**FINAL DECISION  
And  
RESPONSE TO COMMENTS**

**Chevron Gasoline Release**

**At Chillum, Maryland**

**April 2008**

**Figure 2. Existing Vertical & Angle Dual Phase Extraction Wells in Area A and Eastern Ave of Area B**

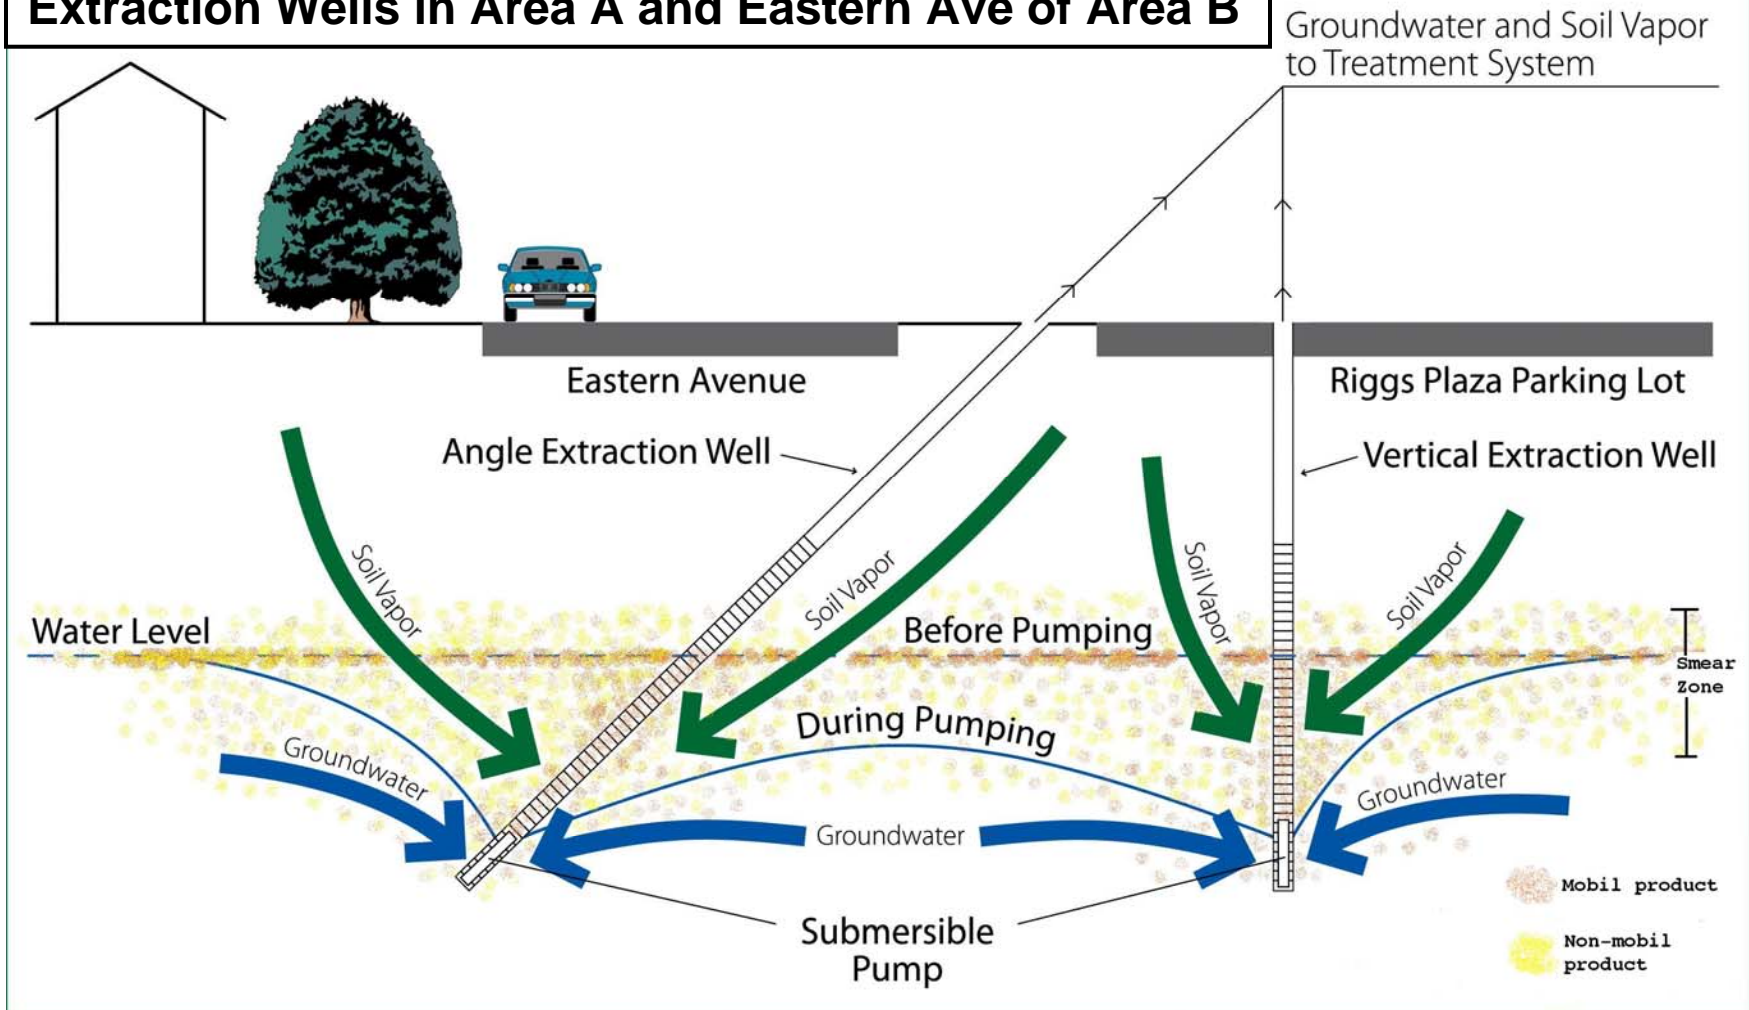
(1) The target capture zone for the angle recovery wells is the liquid gasoline in Area B. As shown in Figure 4 of the SB, Area B encompasses approximately the width of two duplex lots and the length between Eastern Avenue and the adjoining alley.

This component of the Final Remedy is the same as proposed in the SB. Chevron is required to continue operation of the existing groundwater remediation system in Area A, and to expand the system into Area B by installing angle recovery wells under Eastern Avenue up to private property boundary. All new recovery wells will be connected to the existing groundwater treatment unit. The final design and the number of angle wells needed will be determined in the design phase. Chevron is required to obtain all necessary permits from the District to install the angle wells (Figures 1 and 2).

The angle wells will be connected to the existing treatment system which has enough capacity to handle the additional flow. The angle wells will be designed to draw only a few gallons per minute, and will not be strong enough to overload the electrical system, shift house foundations, or draw the plume towards the District side. There will be a slight increase in vapor emission on the Maryland side from the treatment unit, but the increase will fall within the permitted limits.

**Figure 3 Independent Remediation System in alley of Area B**

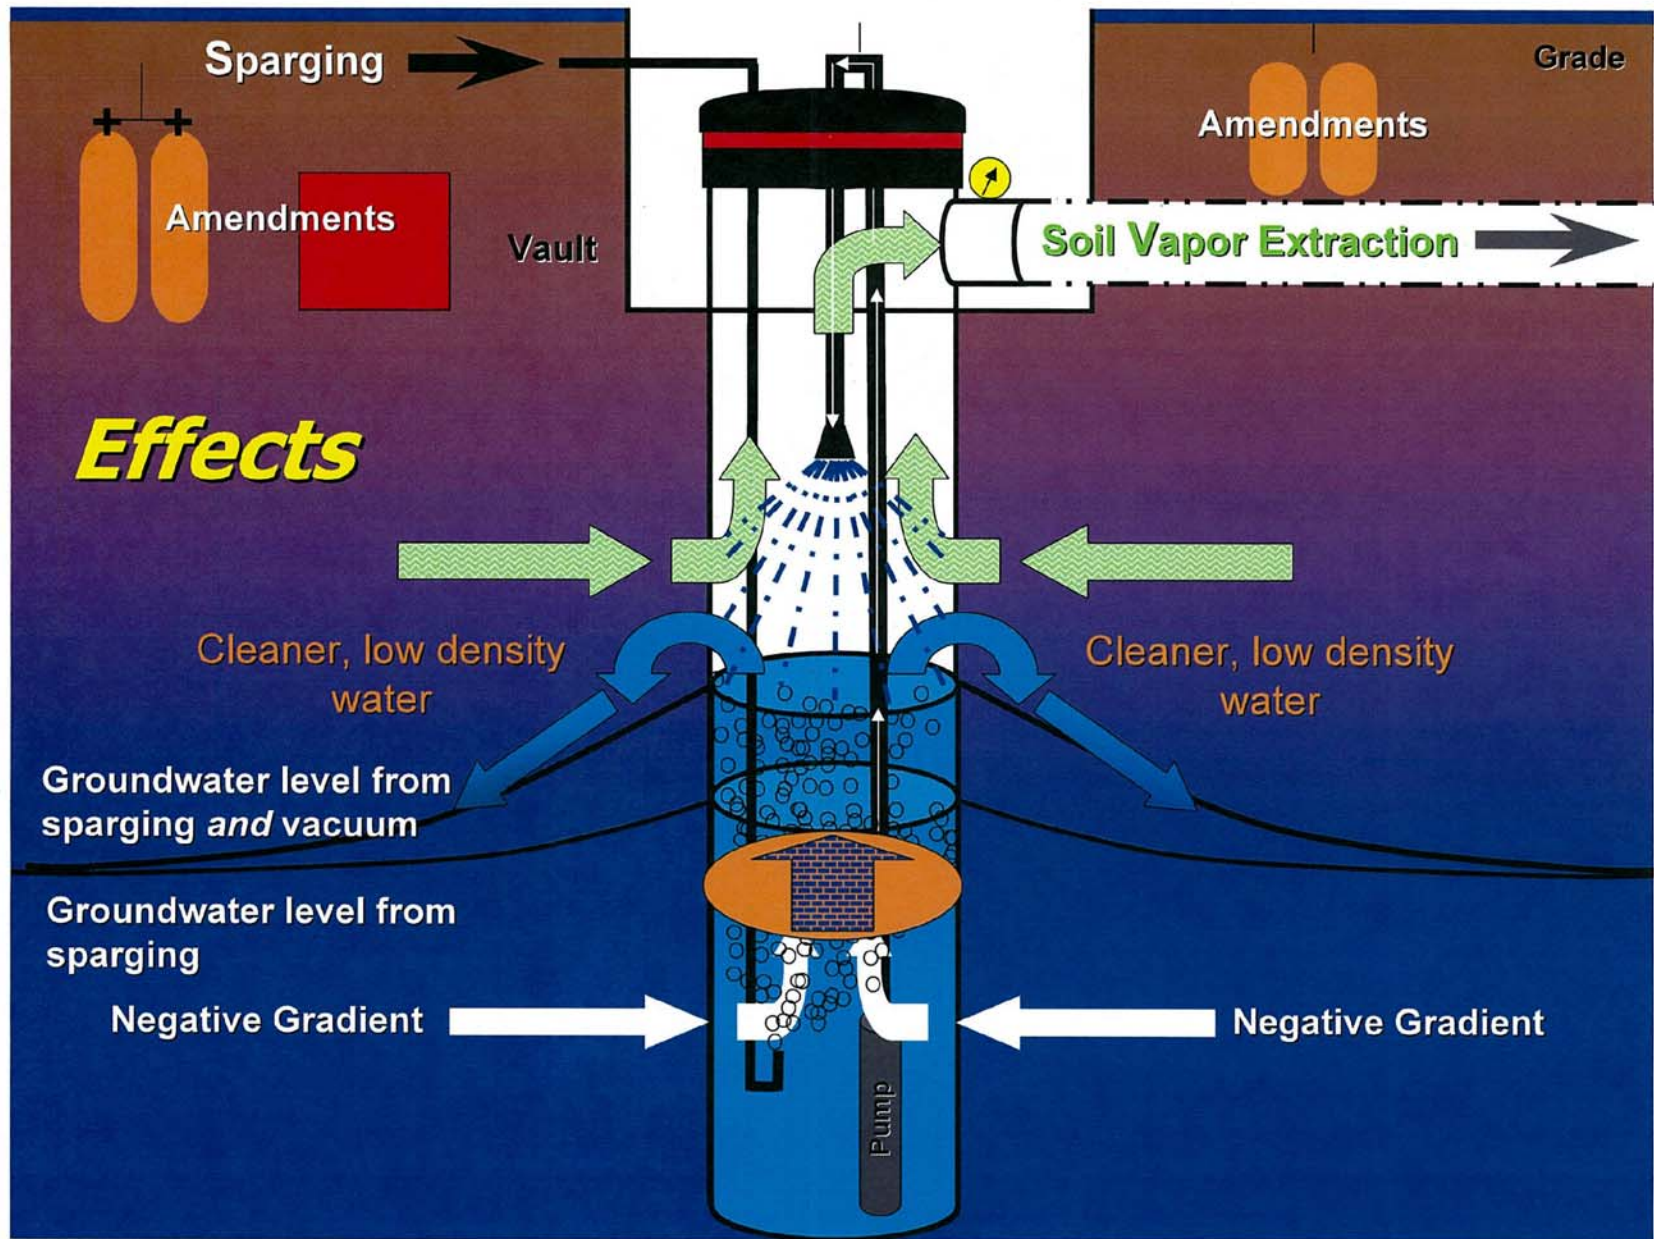
The 60-day public comment period and public meeting which was held on September 6, 2007 provided the opportunity for the property owners to voice their support for or objection to the proposed remedy. Based on overwhelming requests received from the public, EPA has made its final decision to modify the proposed remedy as set forth in the SB by adding two remediation components, both located on the District side. A

Based on public comments received and evaluation of the remedy selection criteria, EPA has included in its final remedy an independent remediation system in the alley of Area B to remove liquid gasoline, and an oxygen injection curtain in the alley of Area C to accelerate degradation of the dissolved phase plume where oxygen is limited.

Based on comments received during the public comment period and evaluation of the remedy selection criteria set forth in Section VIII of the SB, EPA has decided to add this component to the Final Remedy. EPA is requiring Chevron to install an Independent Remediation System (IRS) in the alley behind Eastern Avenue in Area B. The IRS uses an innovative recovery well design by combining multiple treatments (soil vapor extraction, recirculation groundwater pumping, and air sparging) inside a large diameter well, thereby reducing space needed to place equipment above ground. Additionally, EPA will require Chevron to design an underground vault to house most of the above-ground equipment. There will be short-term construction disruptions, but long-term disruptions due to noise, traffic and aesthetic interferences will be minimized by fitting most equipment below grade. The IRS has no net groundwater discharge because dissolved phase contaminants are vaporized inside the well and will be removed by a soil vapor extraction pump. Unlike the existing dual phase extraction system, the IRS will not depress groundwater, and, therefore, will not draw the plume further into the residential area. There will be stack emission from the IRS, which will be treated by activated carbon or catalytic oxidizer to meet District emission standards. The final

design and the number of IRS wells will be determined in the design phase. Chevron is required to obtain all necessary permits from the District to install and operate the IRS (Figure 3).
